Project	IEEE 802.16 Broadband Wireless Access Working Group < http://ieee802.org/16 >
Title	Addition of SS Basic Capability Negotiation in Network Entry Management
Date Submitted	2007-01-16
Source(s)	Jee Hyeon Na, ETRI, E-mail: jhna@etri.re.kr Jaesun Cha, ETRI, E-mail : jscha@etri.re.kr JungMo Moon, PhD, ETRI, E-mail: jmmoon@etri.re.kr Mi-Young Yoon, ETRI, E-mail: myyun@etri.re.kr Sang Ho Lee, PhD, ETRI, E-mail: leesh@etri.re.kr Yun Won Chung, PhD, Soongsil University, E-mail: ywchung@ssu.ac.kr Ronald Mao, Huawei,
Re:	Call for Comment on P802.16g D6 Document
Abstract	This contribution proposes service primitives for network entry.
Purpose	The document should be considered during the resolution of comments on the D6 document.
Notice	This document has been prepared to assist IEEE 802.16. It is offered as a basis for discussion and is not binding on the contributing individual(s) or organization(s). The material in this document is subject to change in form and content after further study. The contributor(s) reserve(s) the right to add, amend or withdraw material contained herein.

Addition of SS Basic Capability Negotiation in Network Entry Management

Figure xxx – SS Basic Capability Negotiation Primitives (MS and BS)

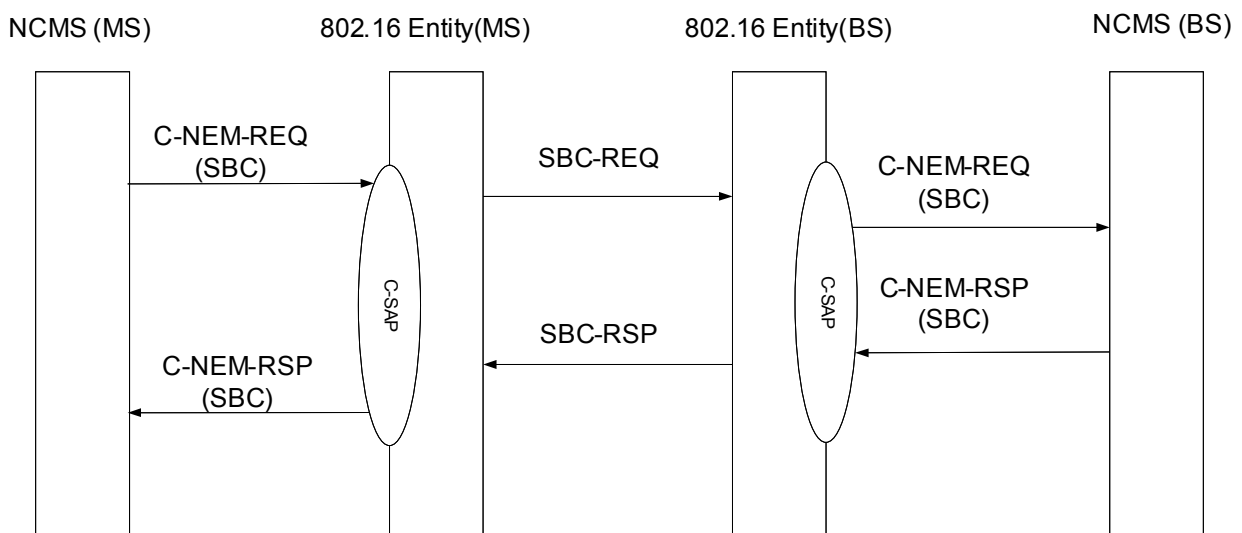
In Section 14.2.7, network entry management is described, where network entry procedure consists of ranging, registration, and network attachments. The current network entry management, however, does not contain SS basic capability negotiation during initial network entry. Since NCMS (MS) does not know when it should generate C-NEM-REQ(registration) primitive without indication from 802.16 Entity(MS) because it does not know whether SS basic capability negotiation procedure in MAC layer is completed or not, SS basic capability negotiation should be included for network entry management procedures. Thus, in this contribution, we propose to add SS basic capability negotiation primitives and related procedures in Section 14.2.7.

[Inserts the following figure between figure 498 and figure 499 in Section 14.2.7.1]
